# CITY OF ALBUQUERQUE

**RE: Signal Village Subdivision  
Signal and Ventura NE  
Grading Plan Stamp Date: 2/20/19  
Drainage Report Stamp Date: 2/20/19  
Hydrology File: C20D078**

**Re: Signal Village Subdivision Grading Plan and Drainage Report (C20D078)**

SHEET No.  
**C501**

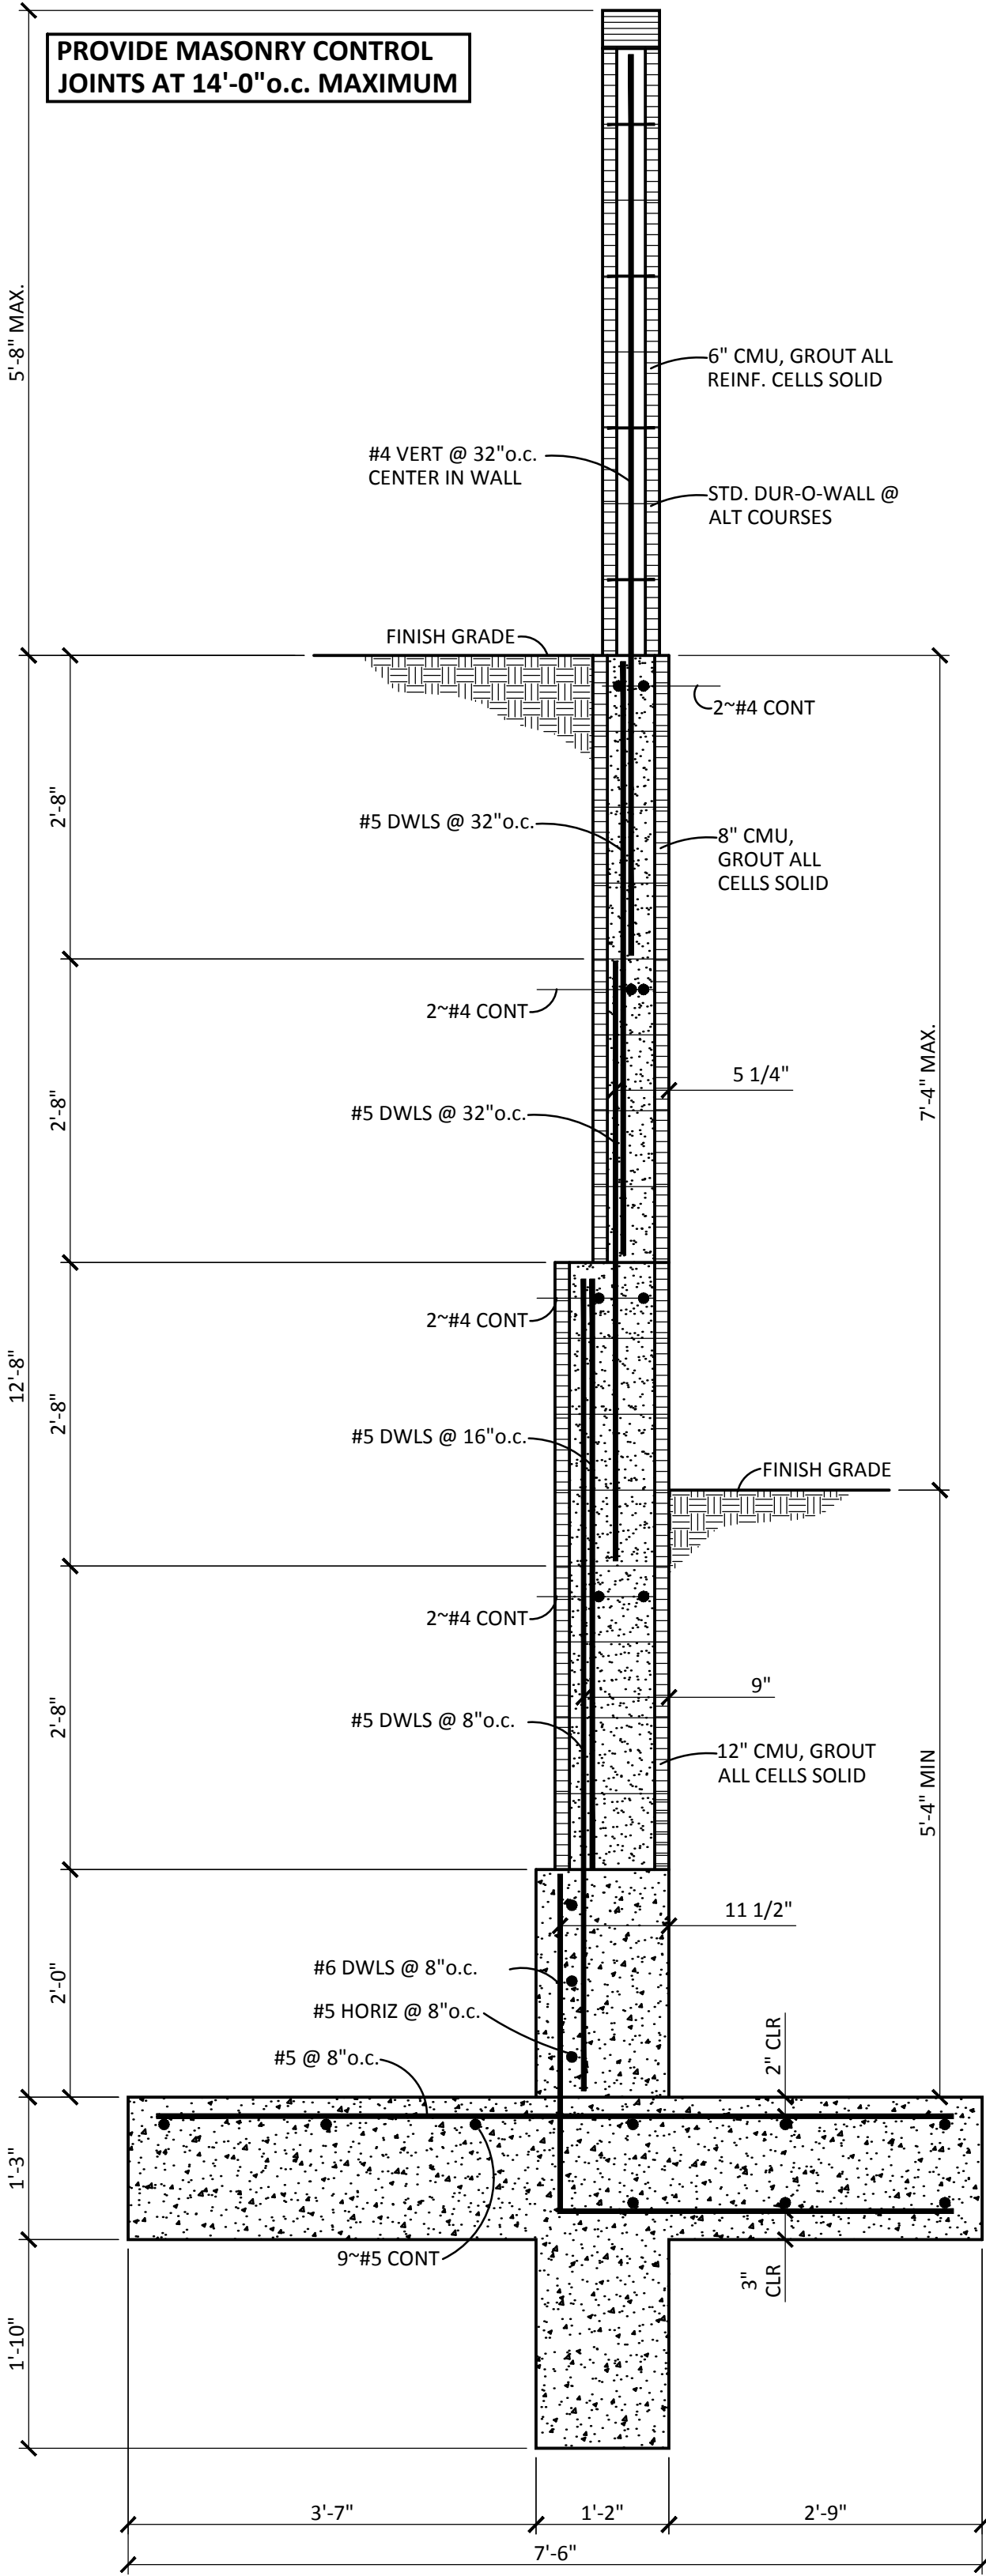
- c. The section of the channel on the west property line is incomplete on sheet C501. It should also show the existing grade on both sides of the existing wall with horizontal and vertical dimensions to the property line and the new retaining wall /channel. The channel, new retaining wall, existing wall, and property line need to be clearly shown on the plan and profile on sheet C105.

- d. The street sections on sheet C501 are not consistent with what is shown on the G&D Plan and on the infrastructure list. Signal Ave is to have a 32' FF roadway but it is mislabeled 30' on the G&D Plan and on the section. The onsite road is 24' FF offset to one side to accommodate sidewalk on the north side but the sidewalk is missing on the section and on the G&D Plan. All elements of the roadway, sidewalk and easement must have dimension ties to the property line on both the section and the G&D Plan.
